DE YOUNG MUSEUM AT GOLDEN GATE PARK - ACCESSIBILITY REVIEW

DE YOUNG MUSEUM
AT GOLDEN GATE PARK
PARKING, PATHS OF TRAVEL,
AND SHUTTLE SERVICES -
ACCESSIBILITY REVIEW

NOVEMBER 2021

Figure 1. Loading Zone Code Requirements¹³**FIGURE: PASSENGER DROP OFF AND LOADING ZONE ACCESS AISLE****C. Parking Lots**

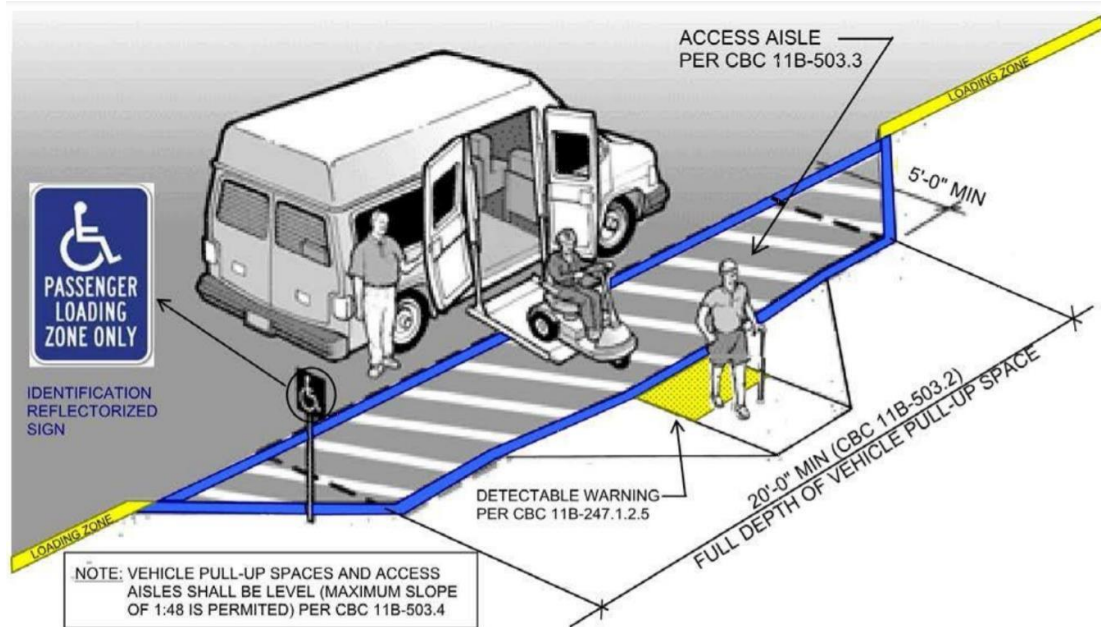
off zones. CBC and ADAS require a minimum 20 foot long by 8 foot wide vehicle pull-up area (11B-503.2). Adjacent to that is a required 20 foot long by 5 foot wide access aisle to load/unload people from the vehicle (11B-503.3). This entire area must be located on the same level and connected to an accessible route (11B-503.4). The minimum height of the vehicle pull-up spaces is required to provide a minimum clearance of 114 inches. (11B-503.5). The minimum clearance would be required at the vehicle pull-up spaces, access aisles serving them, and a vehicular route from an entrance to the passenger drop-off and loading zone to a vehicular exit. The parking garage provides 98-inch clearance.

Comment#: 35

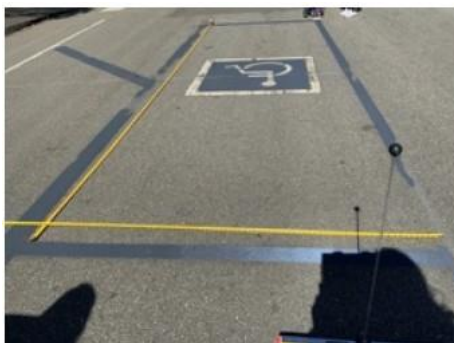
PROWAG R310.2

Floor/Area: Street Parking
Room/Spot: MLK Jr Dr.
Notes: 24

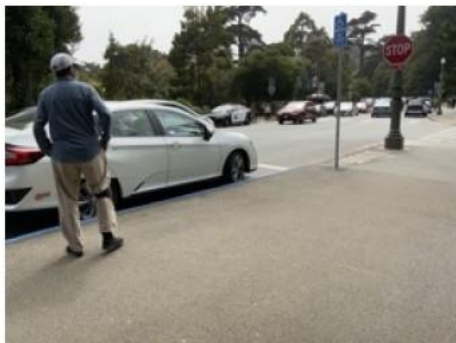
Comment#: 57

Where the width of the adjacent sidewalk or available right of way exceeds 14.0 feet, an access aisle 5 feet wide shall be provided at street level the full length of the parking space and shall connect to a pedestrian access route. The access aisle shall comply with R302.7 and shall not encroach on the vehicular travel lane. Exception is allowed at locations where adjacent street or sidewalks have not been altered, an access aisle would not be required provided that the parking space is located at the end of the block face.

Floor/Area: Street Parking
Room/Spot: MLK Jr Dr.
Notes: 26

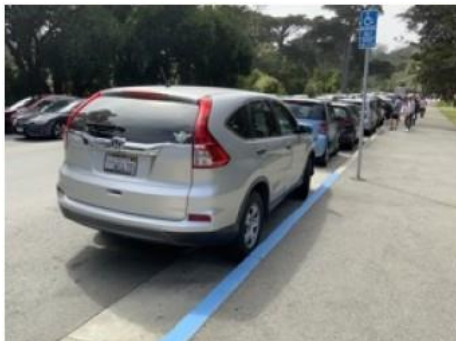
Comment#: 59

Where the width of the adjacent sidewalk or available right of way exceeds 14.0 feet, an access aisle 5 feet wide shall be provided at street level the full length of the parking space and shall connect to a pedestrian access route. The access aisle shall comply with R302.7 and shall not encroach on the vehicular travel lane. Exception is allowed at locations where adjacent street or sidewalks have not been altered, an access aisle would not be required provided that the parking space is located at the end of the block face.
